Sundry Print Report

Well Name: LINDRITH	Well Location: T26N / R7W / SEC 3 / NESW / 36.512558 / -107.564926	County or Parish/State: RIO ARRIBA / NM
Well Number: 4-3 13	Type of Well: CONVENTIONAL GAS WELL	Allottee or Tribe Name:
Lease Number: NMSF079161	Unit or CA Name:	Unit or CA Number:
US Well Number: 300390668400D1	Well Status: Producing Gas Well	Operator: EPIC ENERGY LLC

P&A Procedure**EPIC Energy – Lindrith #013**

CONDITIONS OF APPROVAL

Proposed

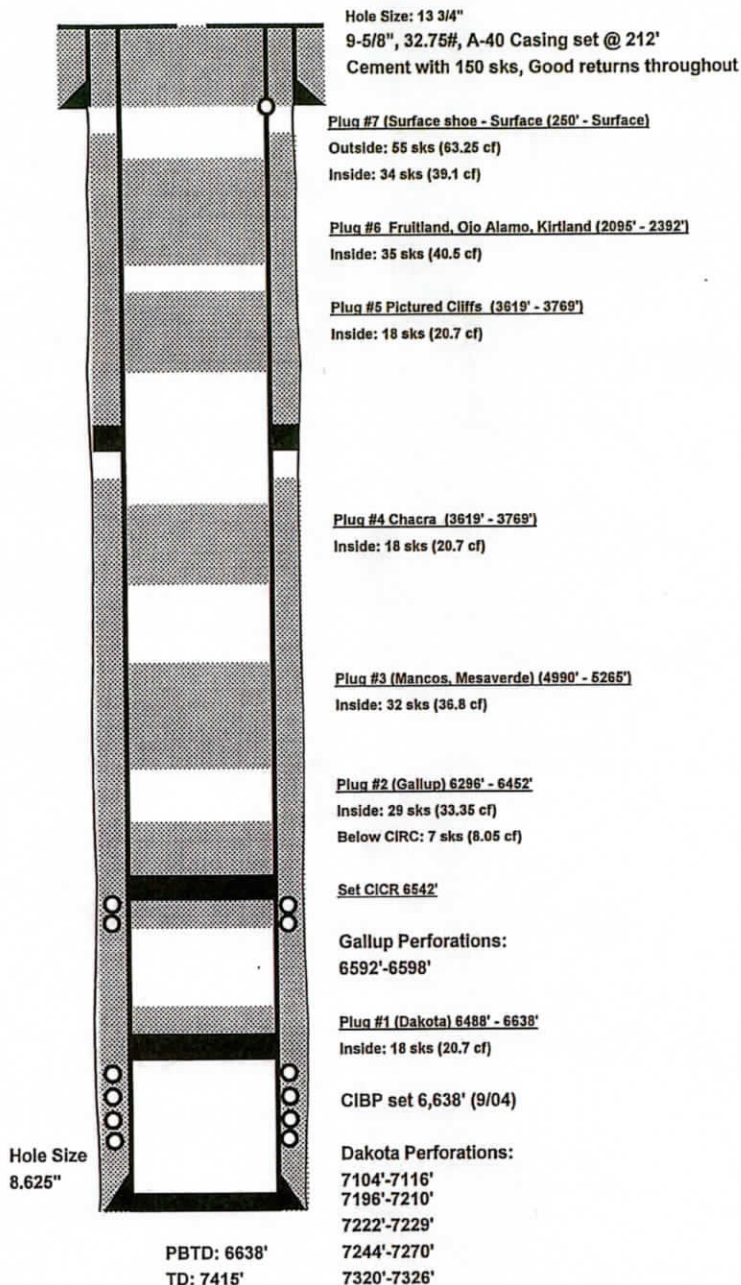
3. The following modifications to your plugging program are to be made:
 - a. Add a plug to cover the Cliff House (top of the Mesaverde) at 4475 feet.
 - b. Plug #4 (Chacra): Bring the top up to 3583 feet to cover BLM pick.

- c. Plug #5 (Pictured Cliffs): Bring the bottom down to 2848 feet to cover BLM pick.
 - d. Plug #6 (Fruitland and Kirtland): Adjust to cover the interval from 2073 feet to 2418 feet or split into 2 plugs to cover BLM picks.

- e. Add a plug to cover BLM pick for the top of the Ojo Alamo at 1985 feet.
 - f. Add a plug to cover BLM pick for the top of the Nacimiento at 1015 feet.

- g. Plug #7 (Surface): Bring down to 262 feet to cover 50 feet below the bottom of the shoe.
